### 7. CASE 23.076, 73 HUDSON STREET, House, c1870 (ARMORY)

PHDC Staff Report June 26, 2023

**Proposal:** The scope of work proposed consists of Minor Alterations and includes:

the installation of ten solar panels to the east slope of the gable-end roof, four on the slope and six on top of the existing dormer.

Arrow indicates project location, looking north.

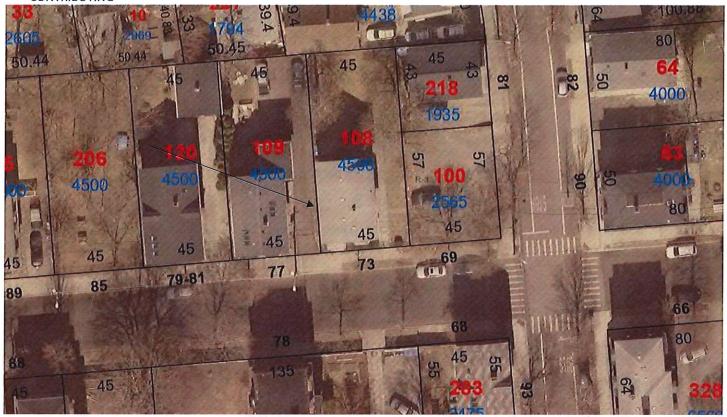
- Some of the modifications as proposed will be (minimally) visible from the public rights-of-way;
- Staff recommends the four panels on the eastern slope be moved as much as possible to the north to decrease possible visibility:

- The lot abutting to the East is currently vacant, however the Commission has approved new construction for a building at this
  location and it is Staff's understanding that a building will be constructed here in the near future, although there may be a new
  developer with a different design (both approved and potential design would be two stories);
